ACCESSIBILITY COMPLIANCE STATEMENT for Review of Environmental Factors (REF) Submission

Our ref:	PAA_24076
Project:	<p>Sophia Waters Sportsground 15 Suncroft Street Chisholm NSW</p> <p>The proposed development is a new sports field that includes the provision of amenities and other external works such as carparking, playground and pedestrian links. The amenities comprise four changerooms, canteen, public toilets and storage areas.</p> 
Client:	<p>Maitland City Council 263 High Street MAITLAND NSW 2320 Attention: Allison Cronin</p>
Documentation Review Date:	13 January 2025
Compliance Status:	<p>Compliant as Documented Refer to following compliance summary.</p> <p>Some items will need to be addressed during construction as noted. Refer to Appendix 1 for construction guidance (accessibility requirements).</p>

Figure 1 | Site Plan in Part

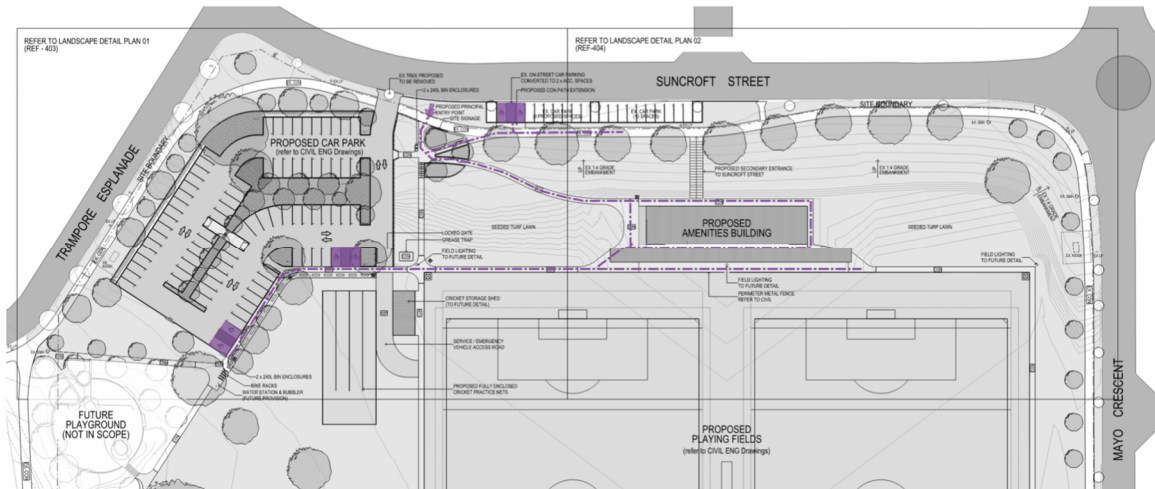
Item:	BCA Ref:	Compliance Status			Comments / Recommendations:
		Y	N	TBC	
2.1 Approach from Allotment Boundary	D4D3	Y	N	TBC	An accessible path of travel is provided from the allotment boundary along Suncroft Street the building entrances. A formed footpath that includes walkways is provided.
2.2 Approach from Carparking	D4D3	Y	N	TBC	An accessible path of travel is provided between the accessible car parking areas and the building entrances. A formed footpath that includes walkways is provided.
2.3 Accessways (Pathways Generally)	D4D3	Y	N	TBC	Pathways are a minimum 1500mm wide and the site plan indicates they are level facilitating an accessible path of

2.5 Walkways	D4D4	Y	N	TBC	<p>Walkways are provided throughout the site to facilitate access to the amenities building from the street footpath and carparking areas.</p> <p>The configuration of the walkways offers compliance with AS1428.1.</p> <p>Nominated gradients are 1:20, 1:23 & 1:31, clear width is 1500mm and length between landings is in accordance with AS1428.1.</p> <p>Maximum allowable crossfall of the walkways is 1:40.</p> <p>Ensure the ground surface abutting the sides of the walkway provides a firm level surface at the same level as the walkway for a minimum of 600mm both sides.</p>

2.6 Stairs	D4D4	Y	N	TBC	<p>Stairs are provided for access to the amenities building from Suncroft Street and also to the west of the building for access to the playing fields.</p> <p>Stair details demonstrate that the overall configuration offers compliance with AS1428.1 (2009). For the main stair, we note 900mm from the boundary is provided.</p> <p>The current documentation indicates no accessibility features to the stairs.</p>

Item:	BCA Ref:	Compliance Status			Comments / Recommendations:
		Y	N	TBC	
					<p>The inclusion of handrails with extensions both sides that are of a consistent height, tactile indicators top and bottom and contrasting non-slip nosing strips to stair treads will need to be addressed to ensure full compliance.</p> <p>For steps within the Spectator Seating, we recommend that contrasting nosing strips be provided to highlight the change in level. Fixed seating will also be provided as a physical barrier.</p>

2.7 Accessible Carparking	D4D6	Y	N	TBC	<p>Four (4) accessible carparking spaces are provided as part of the development – two (2) along the existing carparking along Suncroft Street and two (2) within the proposed carpark.</p> <p>The configuration offers compliance including dimensions of the space, line marking and provision of a bollard.</p> <p>Ensure that the surface is level – maximum fall in all directions of 1:40 (1:33 for bitumen) is required for compliance with AS2890.6.</p>
